REPORT AMENDED BY CPC 2-28-89
(AMENDED BY STAFF 2/23/89)
CITY PLANNING COMMISSION

- A. Negative Declaration
- B. Special Permit to allow the development of a racquet club on 9.5+ vacant acres that includes a 32,000 square foot clubhouse, swimming pool, 17 tennis courts and 161 parking spaces in the Creekside Oaks PUD.
- C. Amend Creekside Oaks PUD Guidelines to reduce the required 25' landscape buffer to ten feet.
- D. Amend Creekside Oaks Schematic Plan to encroach into the adopted 40 ft. recreational easement.

PROPOSAL: The applicant is requesting the necessary entitlements to develop a 9.5+ acre Racquet Club in the Creekside Oaks PUD.

SITE PLAN

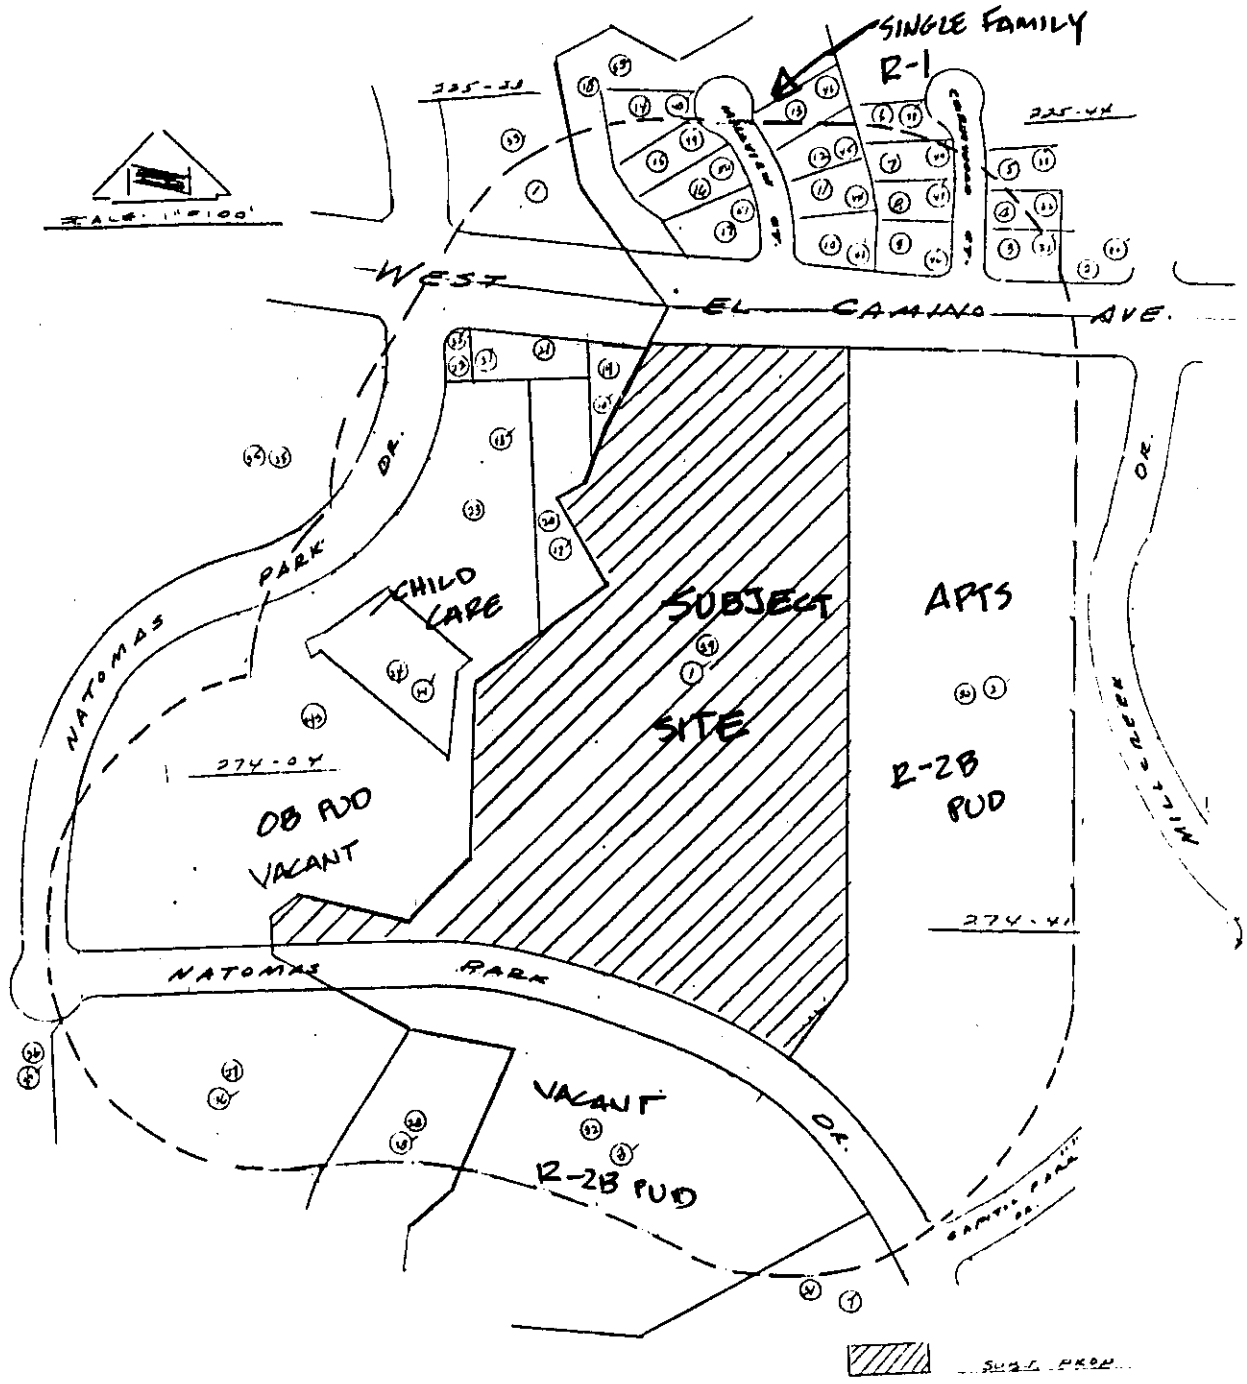
1 Note that this off-site portion of the bike trail 26' min width, is to be dedicated to the City. Show the proposed property line.

2 Clarify the location of the proposed property line for Panmon Slough at the north end of the site. Minimum width shall be 26' (-not 18').

3 Either relocate the conc headwall outside of the picnic area or move the picnic area.
